**HISTORIC PRESERVATION REVIEW BOARD  
STAFF REPORT AND RECOMMENDATION**

Landmark/District:	<b>The Yellow Tavern/Georgetown Historic District</b>	(x) Consent
Address:	<b>1524 33<sup>rd</sup> Street NW</b>	
Meeting Date:	<b>December 15, 2022</b>	(x) Subdivision
Case Number:	<b>22-313</b>	(x) New construction
		(x) Concept

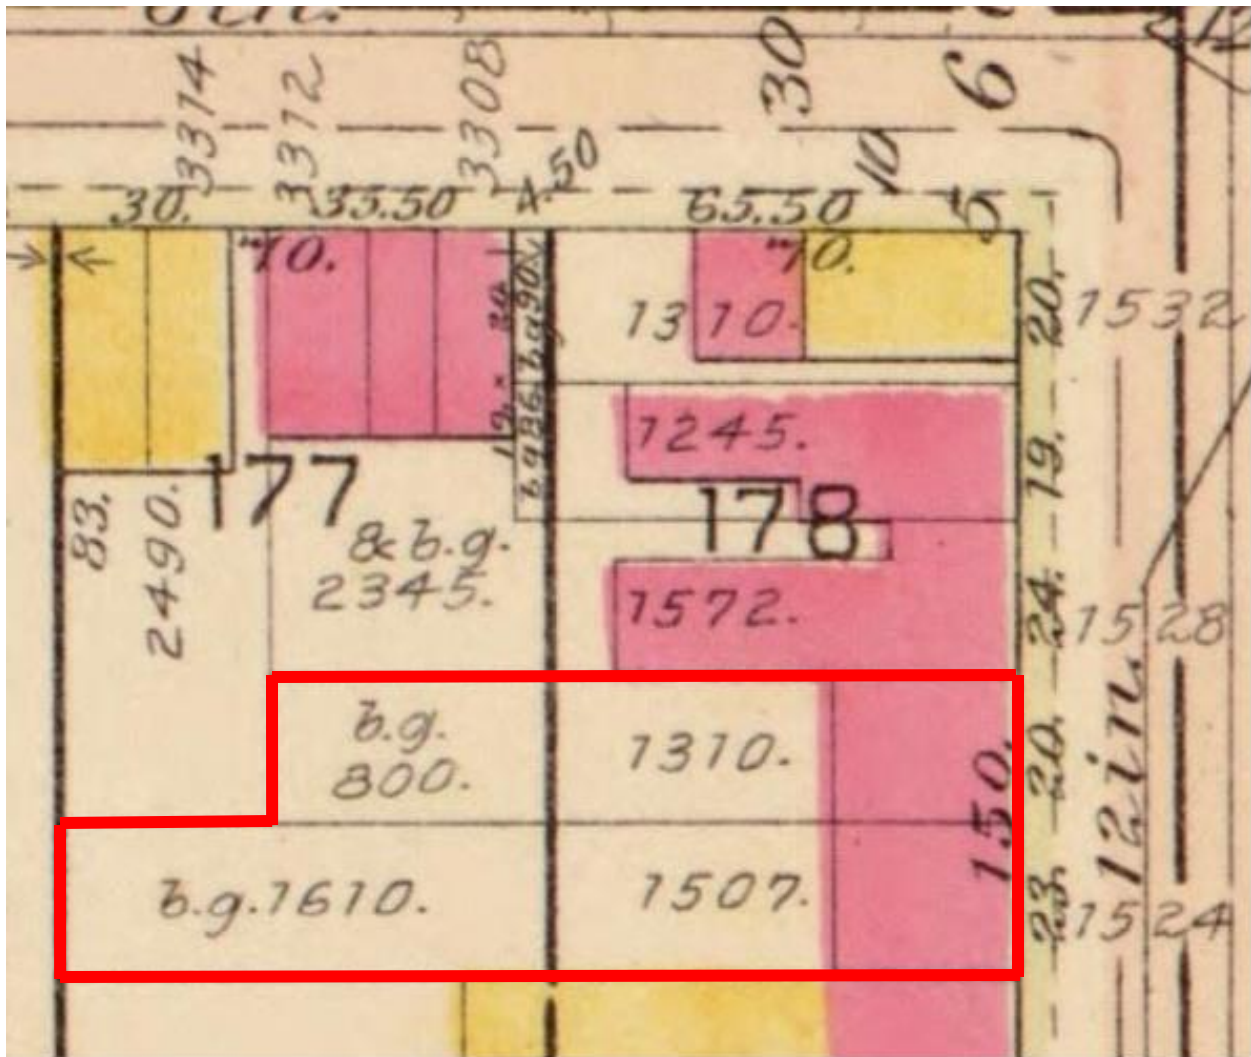
The proposal raises two questions: whether it is appropriate to divide the rear of the lot from the remainder of the property, and whether the further division of that rear lot is compatible with the character of the historic district in terms of its potential for construction. The presented drawings depict what is likely to be built, and the sizes of the proposed lots preclude much more. Most important is whether the subdivision would leave the historic building on a suitable lot that sufficiently retains its extent and character.

It would certainly be neater if the new project did not extend beyond the boundaries of A&T Lot 873, depicted on the last page and extinguished in 1974. That would keep intact the 1524 33<sup>rd</sup> lots more or less as the Offutts, Miss McCandless, and Mrs. Small had known them. But zoning regulations dictate a minimum lot size for new construction, and that fact, plus the retention of an existing driveway over which a neighbor holds an easement, nudges the new lots into the rear of the historic ones.<sup>2</sup>

Legally, a subdivision does not reduce the area of the designated landmark, whatever that might be. But even if the parcel is physically divided by fences along the proposed boundaries, the remaining 33<sup>rd</sup> Street lot will still be sufficiently deep to protect the late-eighteenth-century

buildings and retain their context, leaving about thirty feet between the deepest addition and the shallowest rear lot line. The most significant contextual feature of the rear yard is that it is occupied by substantial twentieth-century additions that largely obscure the historic buildings from that direction.<sup>3</sup> Having to meet the zoning constraints results in irregular back yards for all the resultant lots but, if the imaginary lines manifest as fences and sheds, it will be perceptible mainly from upper stories of adjoining properties and little affect the character of this property or the historic district.

*HPO recommends that the Board approve the concept for the project, including the necessary subdivision, as compatible with and sufficiently retentive of the character and fabric of the property and the historic district and, therefore, consistent with the purposes of the preservation law. HPO further recommends that the Board delegate to staff further review, with the understanding that the permit application will also be reviewed by the U.S. Commission of Fine Arts. If the Board upholds the landmark designation of the property, then any approval of the subdivision will remain subject to Mayor's Agent review.*
